Docket Item # 1
BAR CASE #2010-0218

BAR Meeting
September 1, 2010

ISSUE: Alterations and Waiver of Vision Clearance

LOCATION: 505 South Lee Street

Figure 5. Site Plan

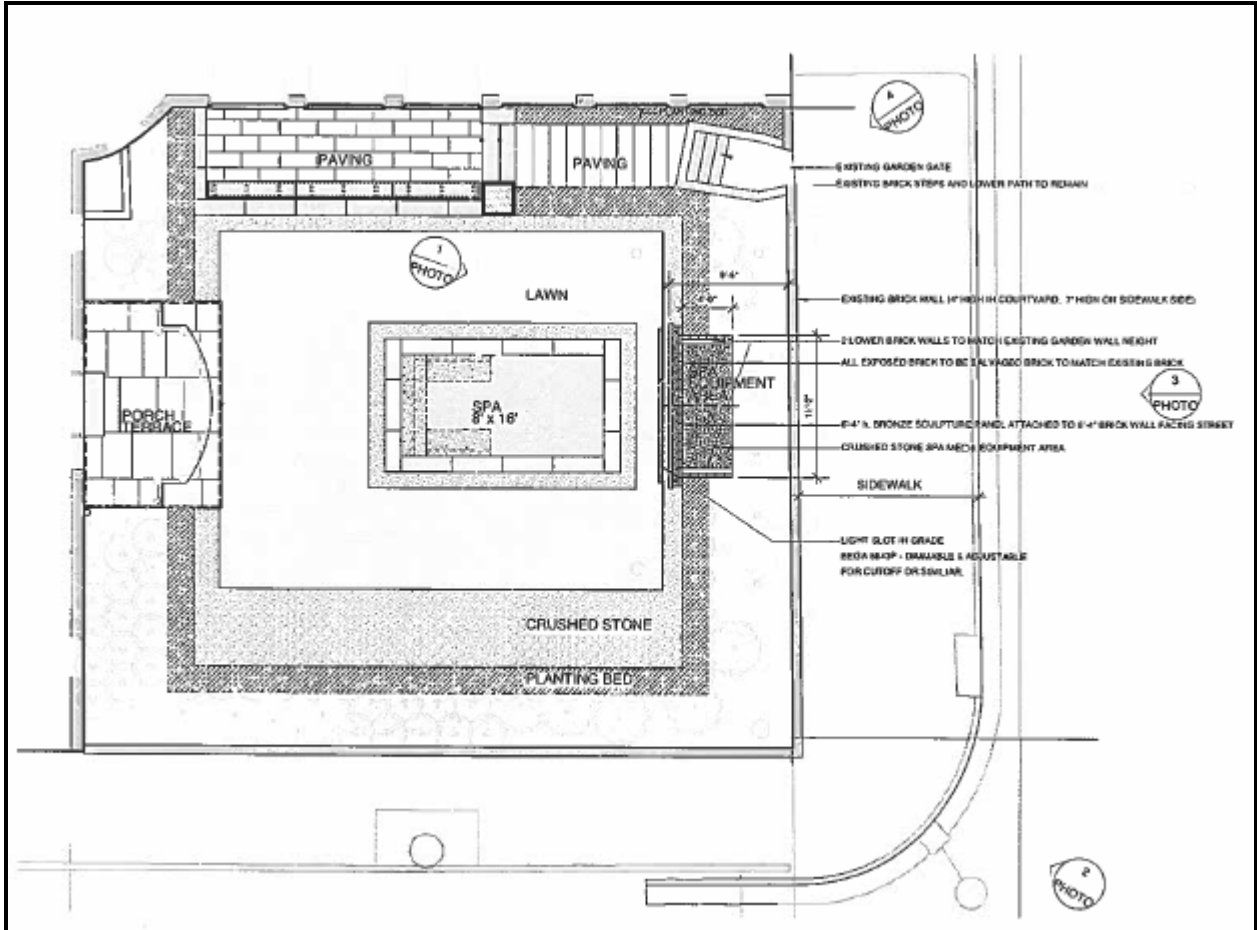
The proposed structure will be located at the rear of an existing heavily landscaped formal garden, inside the 7 foot high perimeter wall and parallel to Wilkes Street. Due to the varying street/courtyard grade differentials, the structure will extend approximately 2'4" above the existing brick wall. However, during leaf season it will barely be visible from either South Lee or Wilkes Streets due to the extremely dense deciduous and evergreen foliage. It will have a footing within the ground; however it will be detached from any other building or structure on the subject property, and may be disassembled and removed in the future, if desired.

Staff has no objection to the Waiver of Vision Clearance, per Section 7-800 of the Zoning Ordinance, and notes that the sightlines already blocked by the existing brick wall will not be altered with the proposal. Additionally, the sculptural wall will be setback from the existing brick perimeter wall and due to existing landscaping will be minimally visible, if at all visible from the public right-of-way.

Figure 6. Elevation Plans

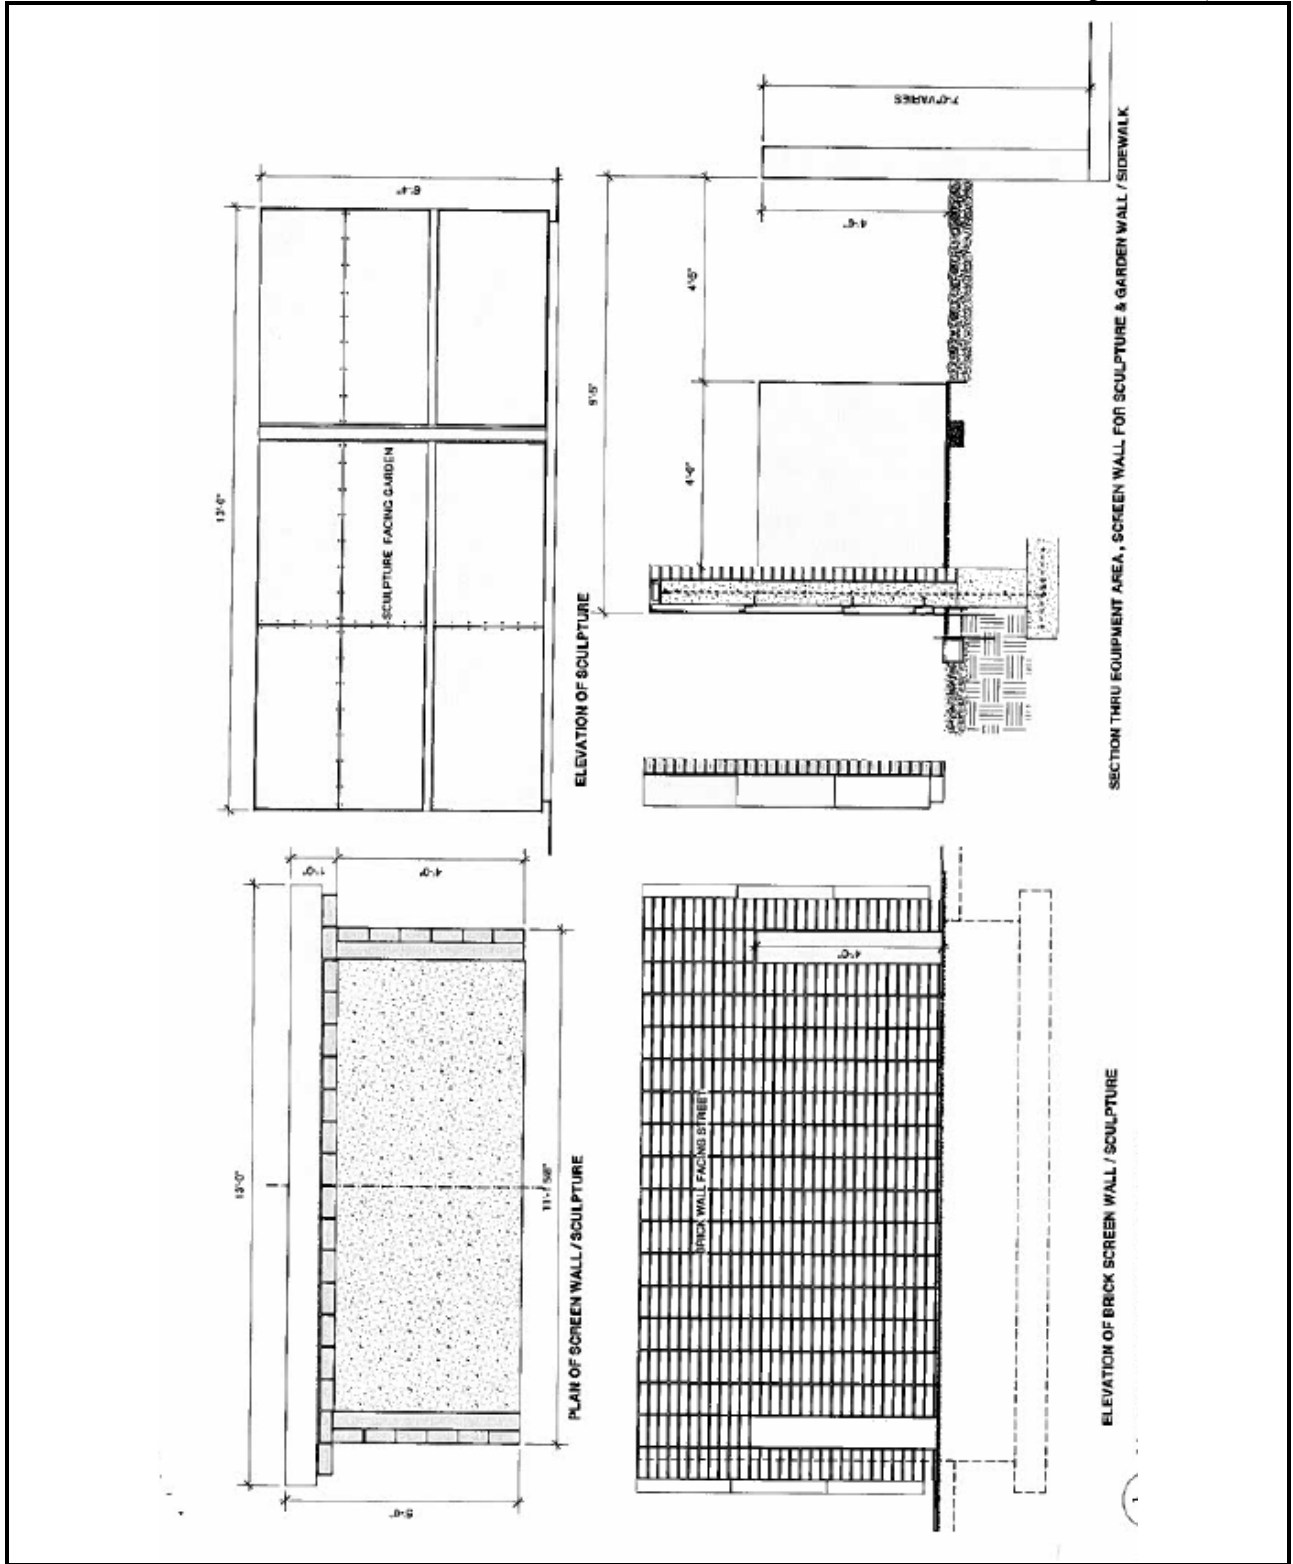
The garden wall is constructed of a concrete form with its street elevation faced with brick and the interior, garden elevation detailed with bronze sculptural panels (see plans pages 8 & 9). The panels will be lit by (5) five ground level, 8 Watt, LED luminaries positioned in front of the bronze façade of the sculptural wall 2'-6" O.C. (see attached photometric plan page 10). The overall height is 6 feet 4 inches. The width is 13 feet.

In Staff’s opinion, the garden sculpture, while somewhat modern in context, meets the requirements of the Design Guidelines. The sculptural wall will be completely free-standing within the boundaries of the existing brick walls and not affixed to any existing historic resources on the subject property. However, due to the differences in grade, 2’4” of the sculptural wall will rise above the height of the existing brick wall. Although significant existing foliage will block the view of the new sculptural wall, the Board has made it a policy not take into consideration foliage when making their decision on a proposal. As such, the rear face of the wall will be fabricated of brick to complement the existing perimeter wall and the surrounding streetscape.

Figure 7. Photometric Illustration

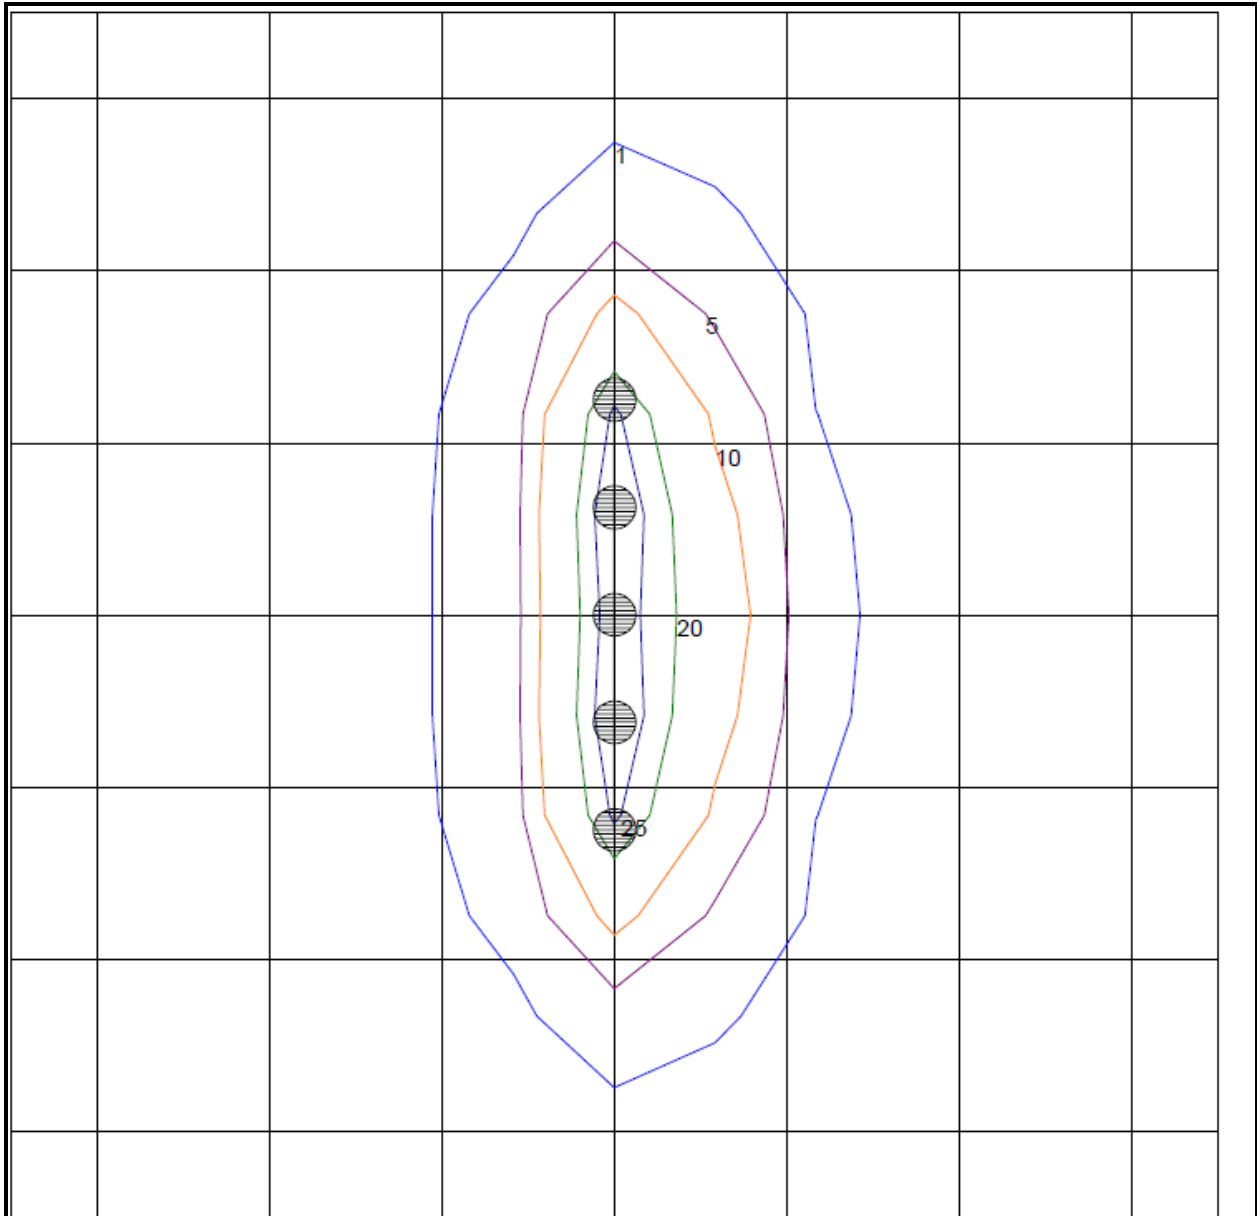
The design plan also includes a lighting component. As the attached photometric plan illustrates, the owners and their design team have carefully chosen a lighting program which highlights only the sculpture so to not generate any light spillage into the surrounding neighbor’s property. Per the photometric analysis, a light value of one (1) footcandle¹ was measured seven (7’) feet away from the light source at grade and fifteen (15’) feet above the light source into existing foliage. The lights will only be operational when the owners are enjoying the garden. Staff believes that this design is appropriate and compatible with the surrounding streetscape and also enables the
